# Access Compliance Report

## Public Rights-of-Way

Intersection ID: 29758	Main Street: BALLANTYNE COMMONS PY	Cross Street: WILLIAMS POND LN	Location: SW
ADA ID: E981392D6E3C	Ramp Type: MedianPerp	Initial Pass/Fail: Fail	Overall Compliance: No
Severity Score: 12.5			
Codes/Mitigation Info/Possible Solution		Field Measurements/Component Compliance

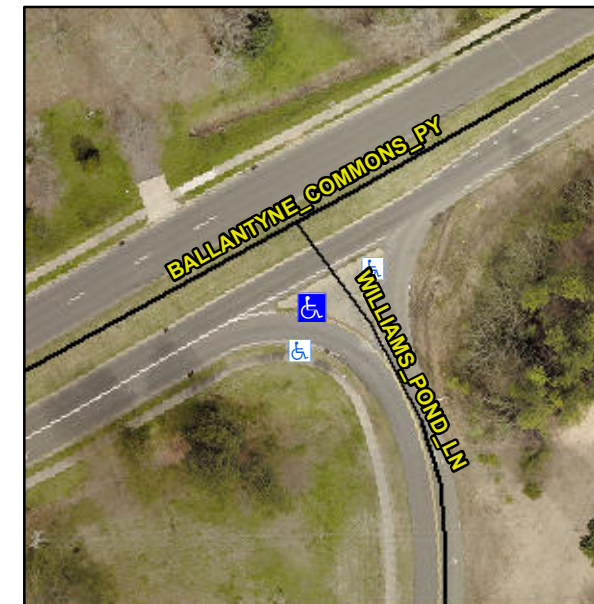
Compliance	Description	Data	Compliance	Description	Data
N/A	Ramp Length (in)	54.0	No	Ramp Slope (%)	9.0
Yes	Ramp Width (in)	48.0	Yes	Ramp XSlope (%)	0.0
N/A	Flare Type LT	N/A	N/A	Flare Type RT	N/A
N/A	Flare Slope LT (%)	N/A	N/A	Flare Slope RT (%)	N/A
N/A	Flare Traversable LT?	N/A	N/A	Flare Traversable RT?	N/A
N/A	Landing Length (in)	N/A	N/A	DWS Provided?	N/A
N/A	Landing Width (in)	N/A	N/A	DWS Contrast?	N/A
N/A	Landing Slope (%)	N/A	N/A	DWS Length (in)	N/A
N/A	Landing X Slope (%)	N/A	N/A	DWS Full Width?	N/A
N/A	Landing Curb? (Y/N)	N/A	N/A	DWS Offset (in)	N/A
N/A	Shared Landing?	N/A			
N/A	Gutter Ponding?	N/A	N/A	Gutter Slope (%)	N/A
N/A	Gutter Lip Ht (in)	N/A	N/A	Gutter X Slope (%)	N/A
N/A	Painted X Walk1?	No	N/A	Painted X Walk2?	N/A
	X Walk 1 Direction	To SW		X Walk 2 Direction	N/A
N/A	X Walk 1 Width (in)	N/A	N/A	X Walk 2 Width (in)	N/A
	X Walk 1 Slope (%)	0.8		X Walk 2 Slope (%)	N/A
	X Walk 1 X Slope (%)	2.8		X Walk 2 X Slope (%)	N/A

**Remove & Replace Entire Ramp.**
